ORIGINATION FORM

Proposed Revisions to a Standard Plans Index

Index Number: 700-120

Index Title: Enhanced Highway Signing Assemblies

ROADSIDE SIGN ASSEMBLY-7

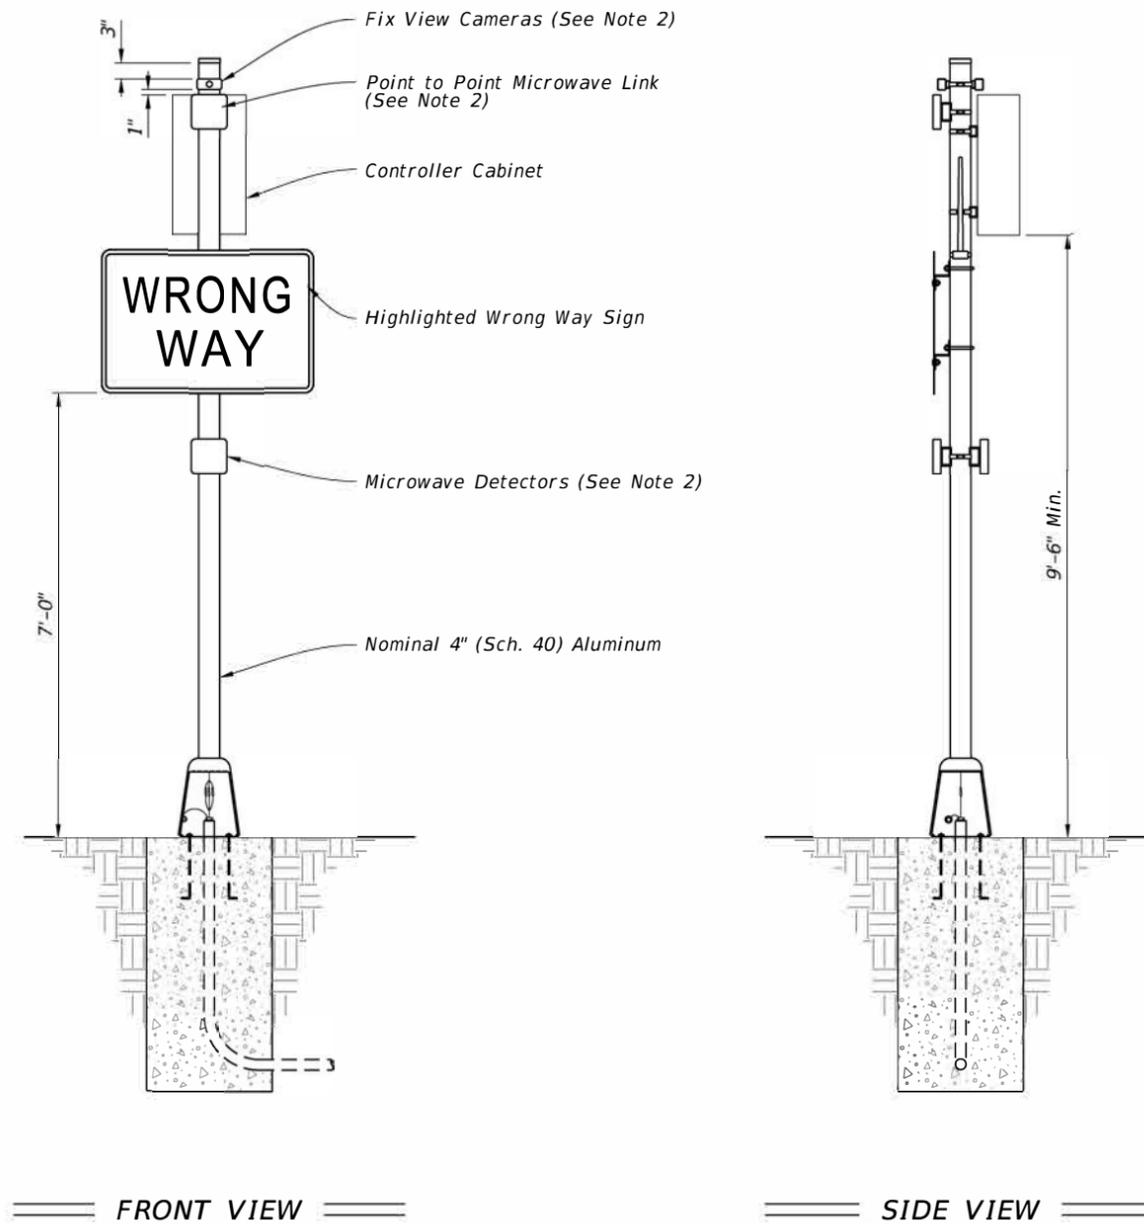
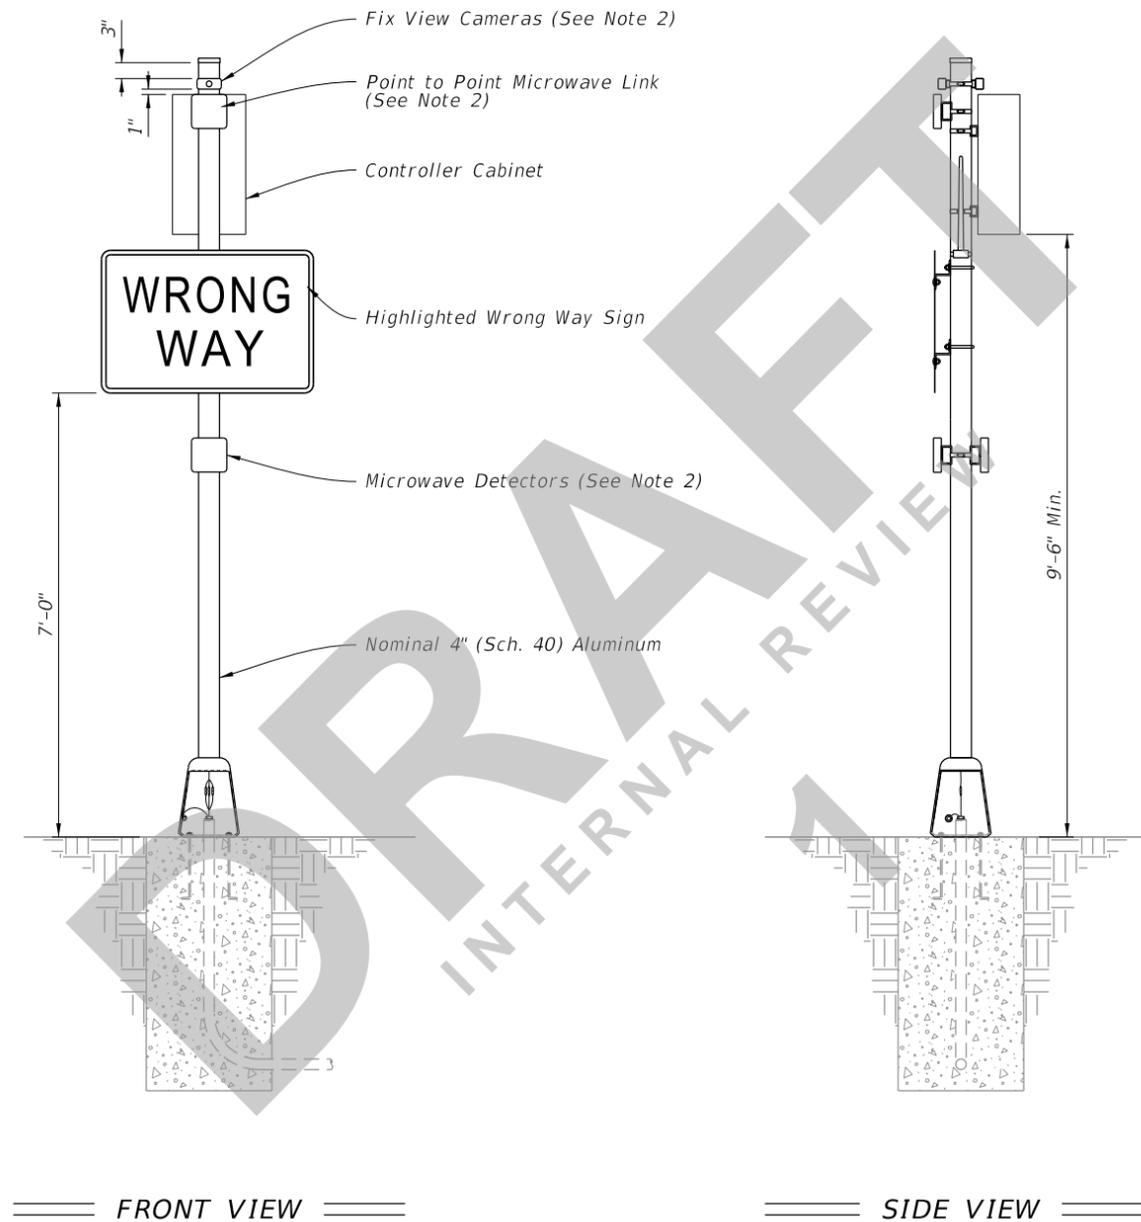
Sheet 9: Changed Note 1; Added Note 3.

The auxiliary pole configuration shown on Index 700-120 Sheet 1 of 10 will not work with Roadside Sign Assembly-7 shown on Index 700-120 Sheet 9 of 10 because the batteries used for the Wrong Way Vehicle Detection System weigh more than 170 lbs. A ground mounted controller and battery cabinet provides a safer and maintainable solution for the solar powered option

1. Type A7 Assembly (Conventionally–Powered) is shown. ~~Type B7 Assemblies (Solar–Powered) Similar~~.

3. For solar powered assemblies, install controller and batteries in the same ground mounted cabinet. Install a separate pole for mounting the solar panel. Install the solar panel pole and cabinet as close to the right of way boundary as possible. Orient solar panel to face South.

1. Type A7 Assembly (Conventionally–Powered) is shown.

3. For solar powered assemblies, install controller and batteries in the same ground mounted cabinet. Install a separate pole for mounting the solar panel. Install the solar panel pole and cabinet as close to the right of way boundary as possible. Orient solar panel to face South.
